**Commonwealth Edison**  
 One First National Plaza, Chicago, Illinois  
 Address Reply to: Post Office Box 767  
 Chicago, Illinois 60690

August 1, 1973

Subject: Proposed Change to Appendix A of DPR-25, AEC Dkt 50-249.

Figure 3.4.2 Sodium Pentaborate Solution Temperature Requirements

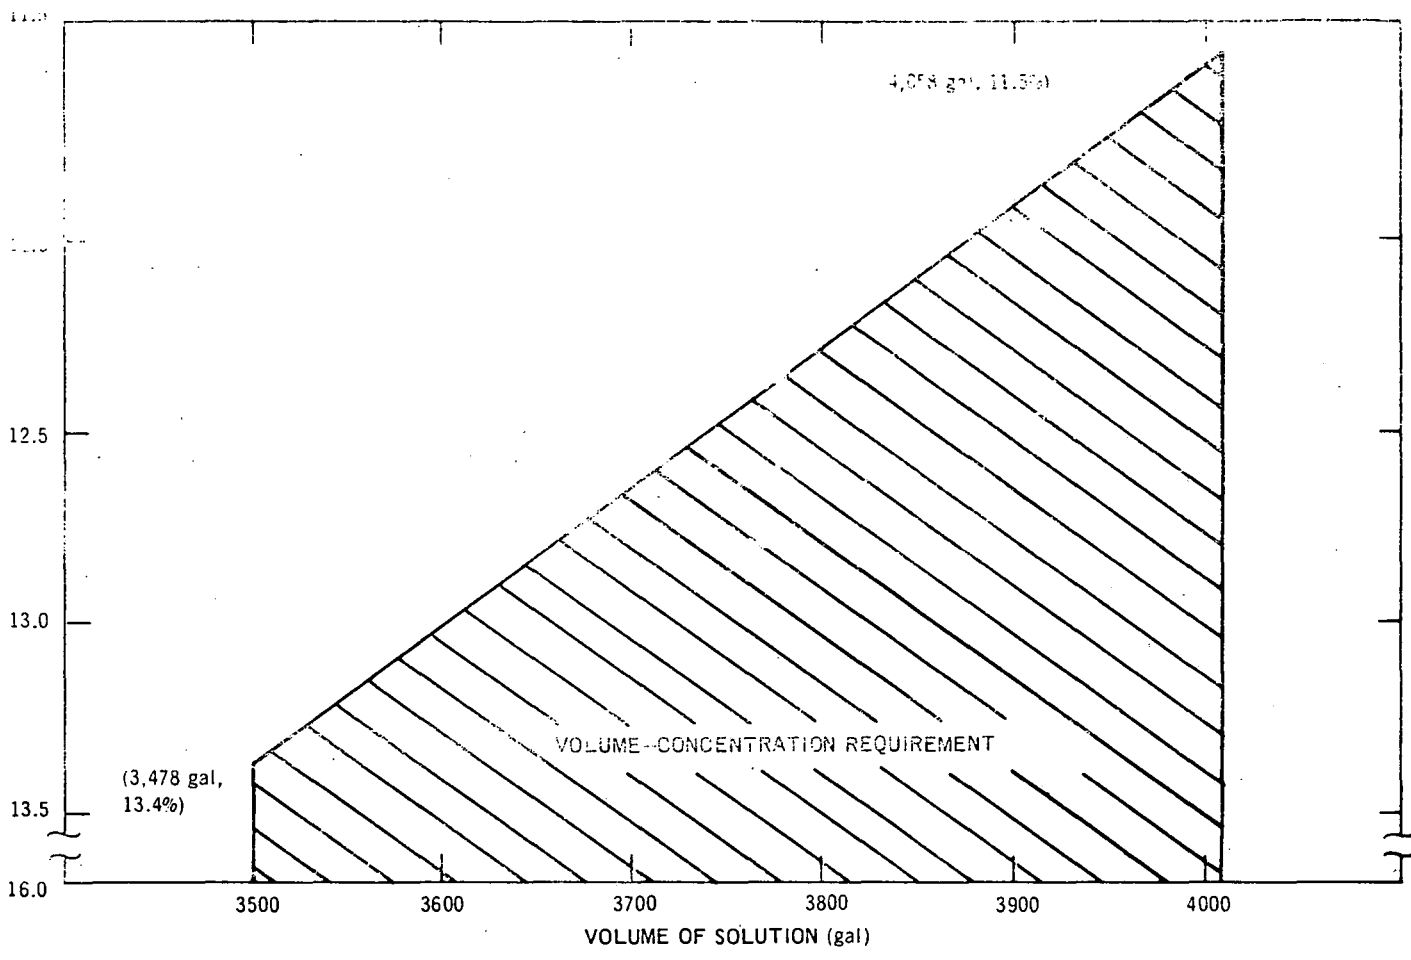
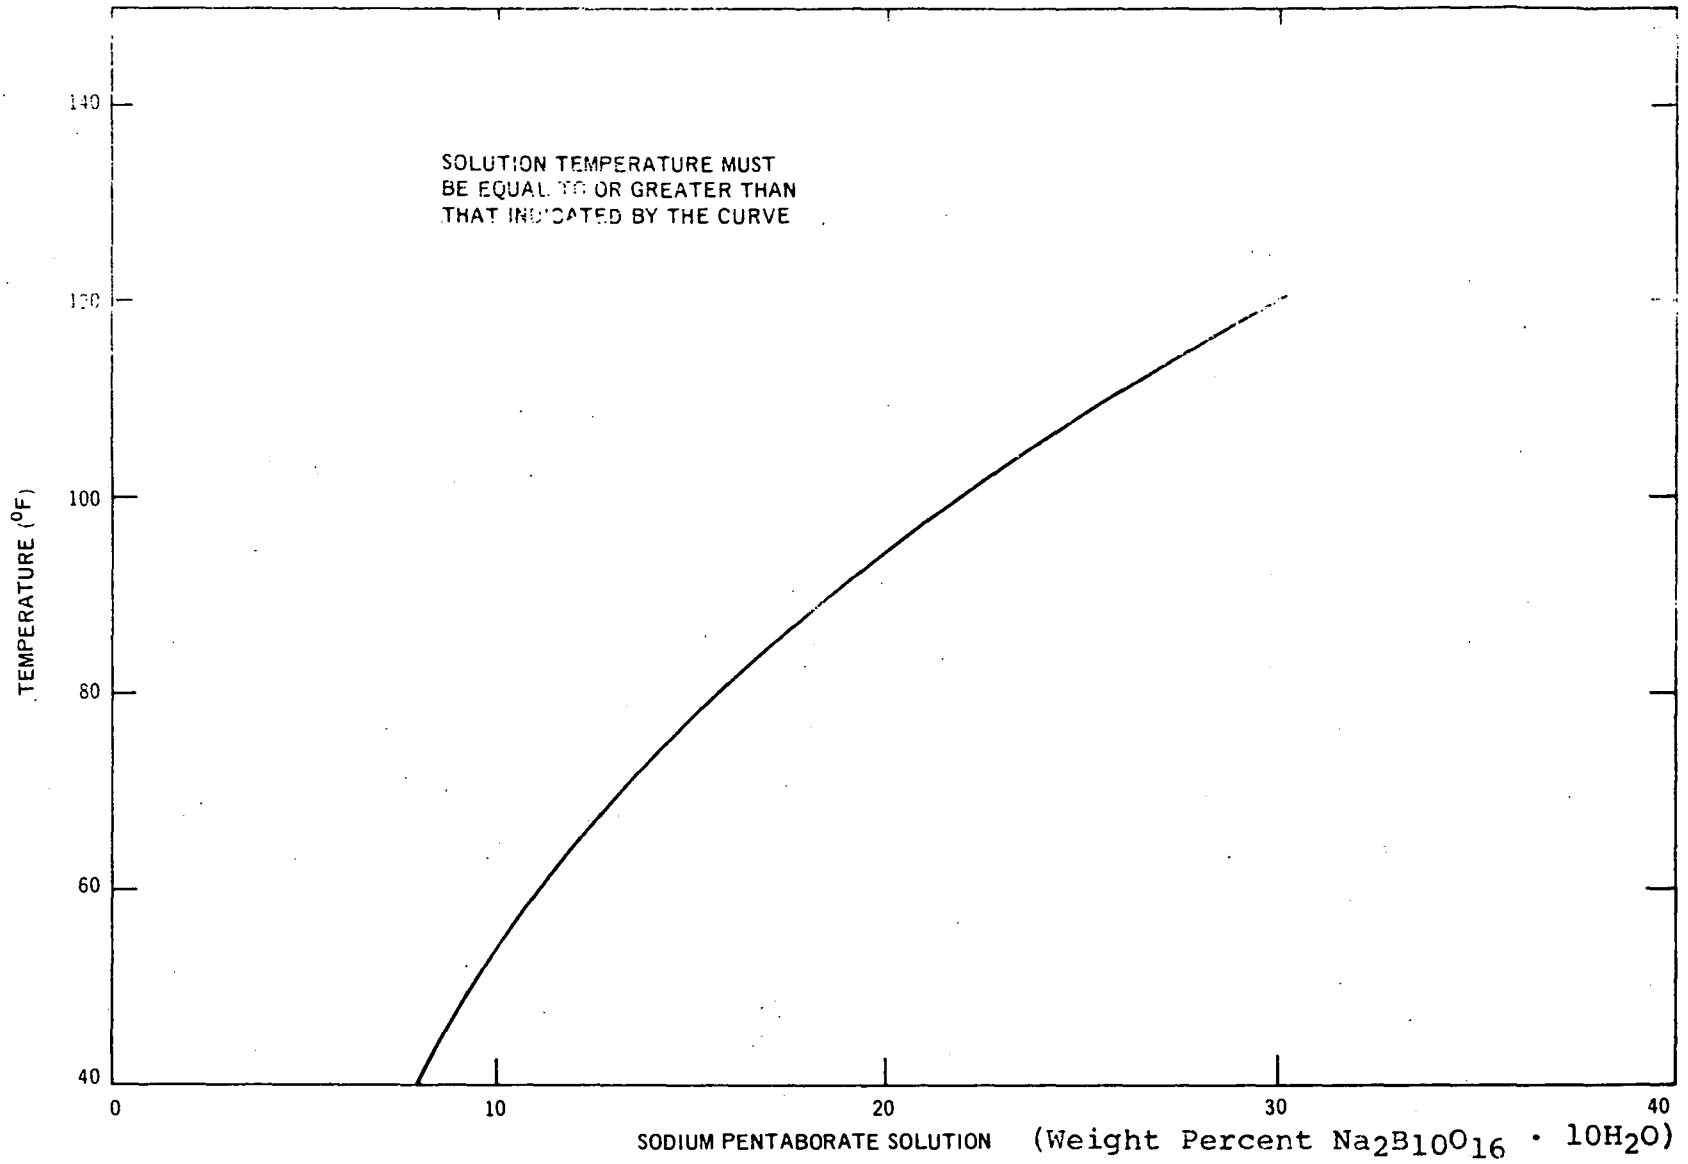
Standby Liquid Control System

This change is to clarify the chemical formula of the sodium pentaborate used in the Standby Liquid Control System. The formula given is consistent with the design of the system described in Section 6.7.1 of the Final Safety

Analysis Report. This clarification is proposed because the chemical formula shown in Table 6.7.1 of the Final Safety Analysis Report contains two typographical errors, i.e.,  $\text{Na}_2\text{Br}_{10}\text{O}_6 \cdot 10\text{H}_2\text{O}$  vs.  $\text{Na}_2\text{B}_{10}\text{O}_{16} \cdot 10\text{H}_2\text{O}$ .
